ADDRESSEES	: ABC Customer Care and Parts Source Owners and operators of coaches listed under 'Application'
VEHICLE MODEL	: CX45, TX45
SYSTEM/SUBSYSTEM	: 6.10 Transmission – Control system
BULLETIN TYPE	: Field Change Program
DATE	: February 18th, 2020
SUBJECT	: Transmission refuses to shift into gear after a low air pressure condition
TERMS & CONDITIONS	: Refer to the warranty section further in this Bulletin

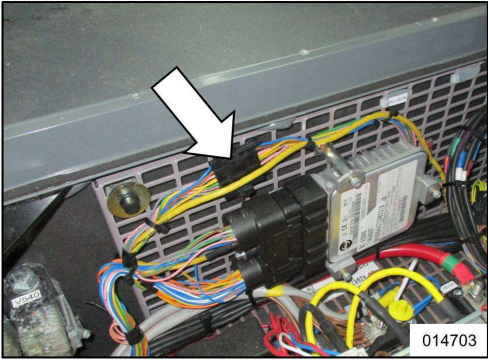
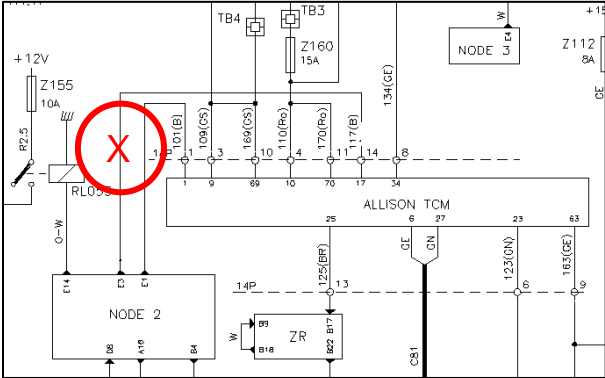
Step	Action
1	<p>Locate the 14-pin connector near the transmission control unit (TCM).</p>  <p style="text-align: right;">Figure 1: Location of TCM (example)</p>
2	<p>Cut the blue wire connected to terminal 14 at approximately 10 cm (4 inch) from the 14-pin connector. Isolate both wire ends with a heat shrink tubing.</p>  <p style="text-align: right;">Figure 2</p>
3	<p>Notify ABC Companies by mail. Write the text “SB1585 completed for VIN.....” in the mail and send the mail to warranty@abc-companies.com.</p>
4	<p>For ABC Companies only: register through the registration button located behind the Service Bulletin on the Van Hool customer portal. Write the text "SB1585 completed" in the field "Remark". Labor allowance will only be awarded after Van Hool has received the registration.</p>
